Ambiguity in PHY layer §8.3 OFDM frequency and timing requirements

Juergen Otterbach / Joerg Schaepperle / Roland Muenzner / Torsten Fahldieck Alcatel SEL AG

Figure 1: Possible differences in OFDM symbol duration

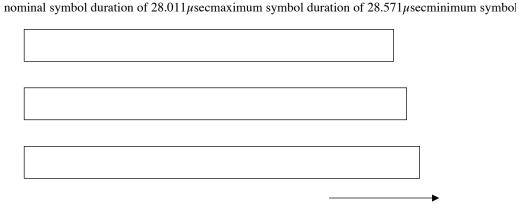
According to this tolerance the SS is allowed to transmit OFDM symbols with differences in duration as shown in Figure 1 with a Cyclic Prefix (CP) time of 1/4 of the "useful" symbol time assumed. The symbol time extension by the CP is 256/4 = 64 samples. The whole symbol is equivalent to 320 samples that correspond to symbol time $T_s = 28.011\mu$ sec nominal.

In a view of the Base Station receiver a nominal symbol duration of 28.011 μ sec is expected. An UL OFDM symbol with maximum symbol duration of 28.571 μ sec is 6.4 samples longer than the expected nominal symbol duration of 28.011 μ sec. A detection of the short preamble using time domain correlator principles would fail.

At the SS, both the transmitted center frequency and the symbol clock frequency shall be synchronized and locked to the BS with a tolerance of maximum 2% of the subcarrier spacing. Additionally the symbol clock frequency at the SS shall be locked to the center frequency at the SS which guarantees a relative tolerance for the symbol clock frequency at the SS of maximum 0.02*(subcarrier spacing)/(center frequency).
